UNITED STATES PATENT AND TRADEMARK OFFICE

APPLICATION NO.	FILING DATE	FIRST NAMED INVENTOR	ATTORNEY DOCKET NO.	CONFIRMATION NO.
10/540,089	06/20/2005	Per-Ingvar Branemark	2816-4	6438

Office Action Summary

DETAILED ACTION

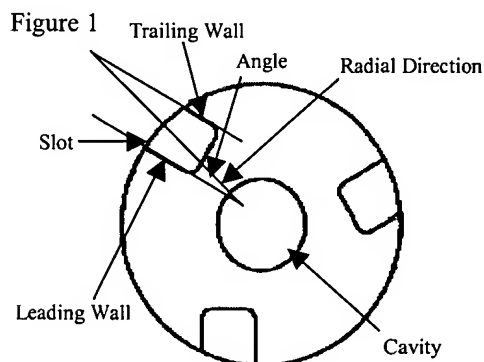
Applicant's arguments filed 11/27/2006 have been fully considered but they are not persuasive. Regarding the applicant's argument that Moore does not disclose slots wherein the radially outermost part of the trailing slot wall defines an angle with the radial direction and slopes obliquely forwardly from within and outwardly in said direction of rotation. The examiner has included Figure 1 above to help further show the reference having the limitations discussed above. As can be seen by the figure, Moore

shows the device having slots wherein the radially outermost part of the trailing slot wall defines an angle with the radial direction and slopes obliquely forward from within and outwardly in the direction of rotation as stated in column 5 lines 1-16.
